# TULSA METROPOLITAN AREA PLANNING COMMISSION

For Meeting No. 2480

May 16, 2007

## MINOR SUBDIVISION PLAT

**SHWIYAT ESTATES**

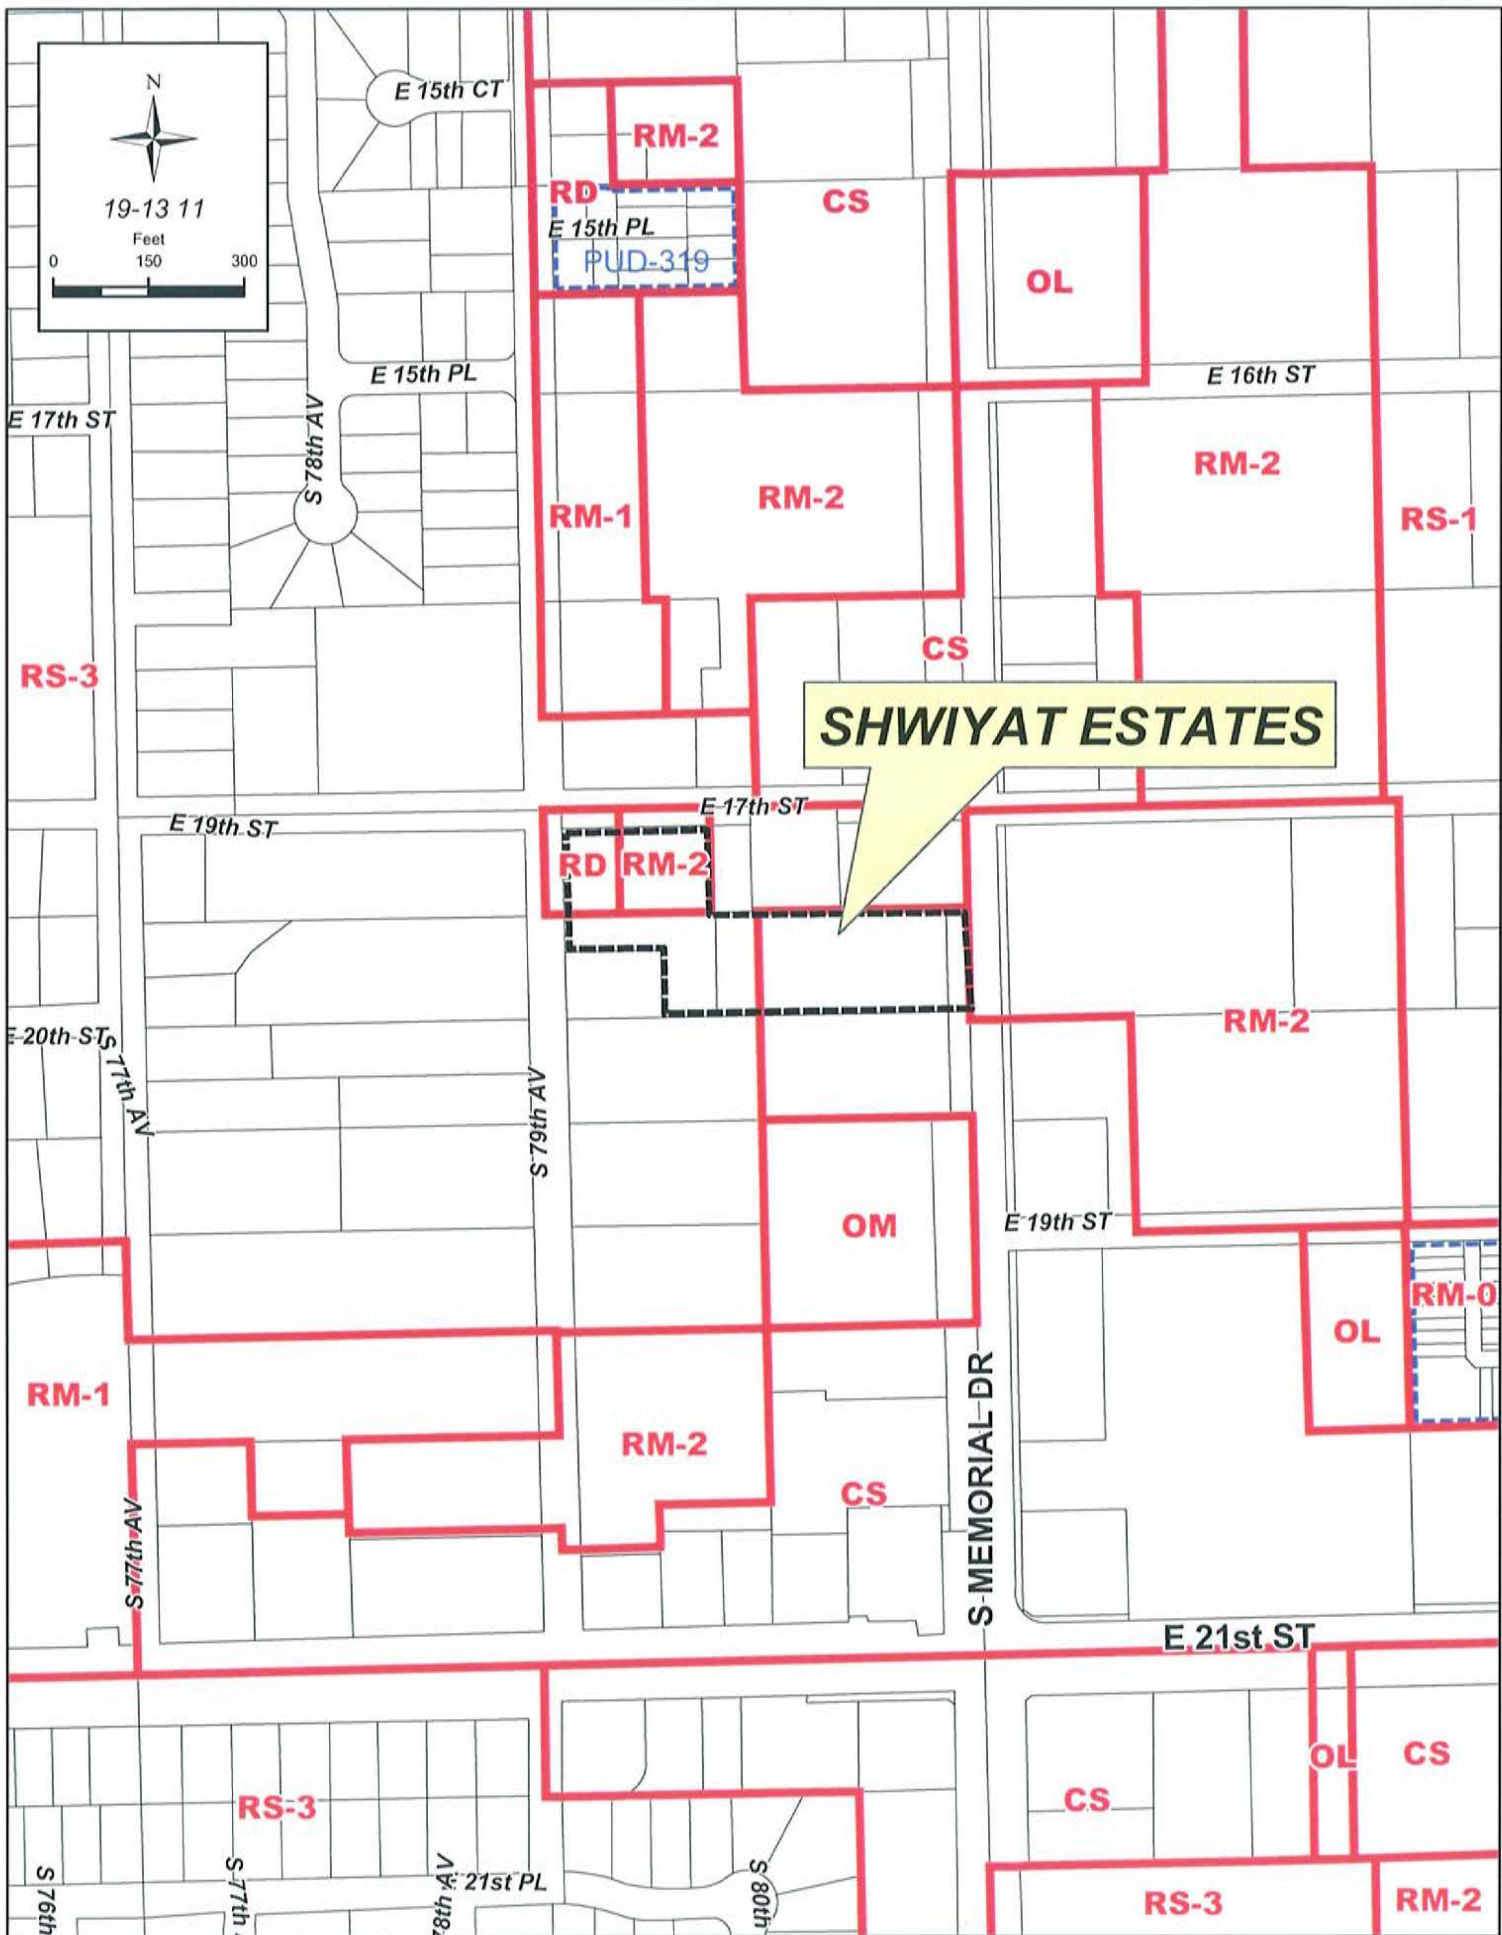
1. **Zoning:** The property is zoned RD, RM-2, CS, RS-3. Sidewalks are required.
2. **Streets:** Provide recording references and dimensions for existing right-of-way dedications on South Memorial and on East 17<sup>th</sup> Street and the other north-south residential street. Dedicate a 25-foot intersection radius on the northwest corner of Lot 2.

3. **Sewer:** Add a 15-foot easement, 7.5 feet each side of the lot line, between Lots 1 and 2, to allow for a future sanitary sewer mainline extension.

4. **Water:** Existing waterlines on two sides of property (Memorial Drive and 79<sup>th</sup> East Avenue). Suggest putting a fire hydrant at the south property line on the west side of Memorial Drive for better fire protection.

5. **Storm Drainage:** Stormwater detention must be provided for the subdivision. The City of Tulsa policy is for all stormwater detention required for a development to be provided at the developmental stage of the subdivision. Show the location and Reserve Area for this facility on the face of the plat. Remove the language in Section II.F and replace it with the standard language for stormwater detention in a Reserve. The existing contour lines are not labeled with their respective elevations, therefore it is not possible to determine from this plan if off-site drainage flows onto this site. Many of the proposed spot elevation call-outs are not readable, due to the size of the lettering and the quality of the print. This site will not be allowed to increase the volume or velocity of drainage runoff flowing to the adjacent properties.

additional dimensioning where the building would encroach. Topographic information, such as existing buildings and culverts, should not appear on the face of a Final plat. Recommend approval as a Preliminary Plat. Please provide standard language in the dedication to declare both the legal ownership and the subdivision name. Legal description needs to include "also being described as..." bearings and distances that match face of plat and tying to section corner.

**GIS:** Please show distance and bearing of dividing line between Lots 1 and 2. Include metes and bounds description with boundary distance for the boundary of the plat.
